METROPOLITAN GOVERNMENT OF NASHVILLE AND DAVIDSON COUNTY

STAFF RECOMMENDATION

**312 Broadway
May 19, 2021**

Application: Rehabilitation, New Construction, Signage
District: Broadway Historic Preservation Zoning Overlay
Council District: 19
Map and Parcel Number: 09306400500
Applicant: Zindagi LLC
Project Lead: Robin Zeigler, robin.zeigler@nashville.gov

right side elevation
 A1.2
 April 30 2021
 LINES-2002.1

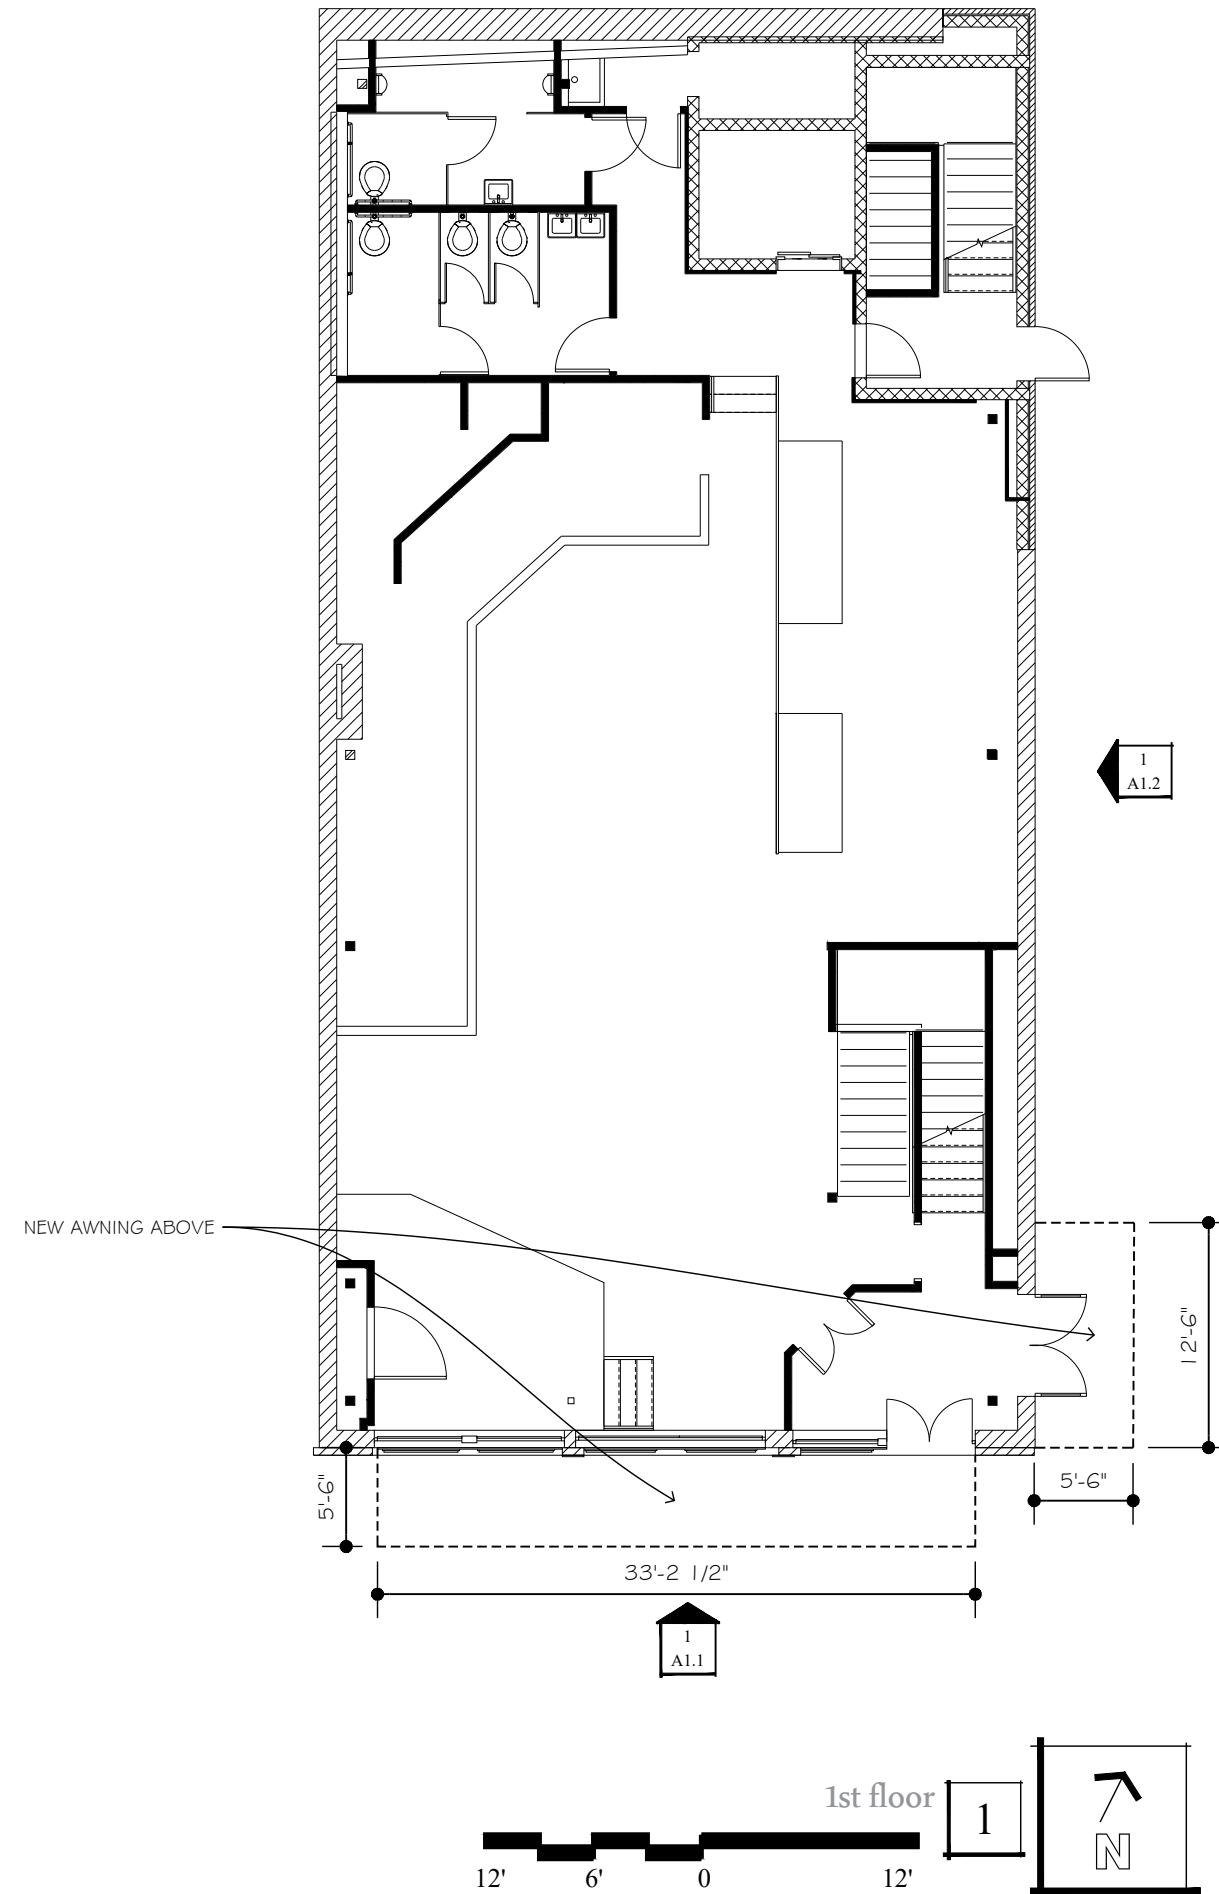
Proposed shingle sign: The proposed shingle sign is approximately nine square feet (9 sq ft) which meets the design guidelines for shingle signs. Information regarding thickness of the sign, materials and lighting were not provided. The location appears to be over a window. To meet the design guidelines, it should be relocated to a pilaster.

Proposed Awning: The canvas awning has a depth of 5' 6", which is less than the maximum allowed by the design guidelines. The material is canvas, which is typical of historic awnings. Lighting is proposed beneath an awning, which can meet the design guidelines as long as the awning is opaque so that the awning itself does not glow and the light is white. Staff recommends a condition that these two conditions be required.

Proposed Building Illumination: Four up-down wall lights are proposed at the street-level. The fixtures are each 7" 1/16 tall, 2" 3/16 wide and 3" deep. The material of the signage and the illumination color was not provided. Staff recommends that the material information is provided for review and that the building illumination be white lighting only.

1. No permits are issued until the violations are corrected;
2. The violations (rooftop awnings and walls and the electronic signage) are removed within sixty (60) days;
3. Shingle sign be relocated to a pilaster and not be located over a window;
4. Applicant obtains approval of the shingle sign dimensions, materials and lighting;
5. Applicant obtains approval of the opaqueness of the awning and the color of the lighting beneath the awning; and,
6. Applicant obtains approval of the building illumination color and the fixture materials.
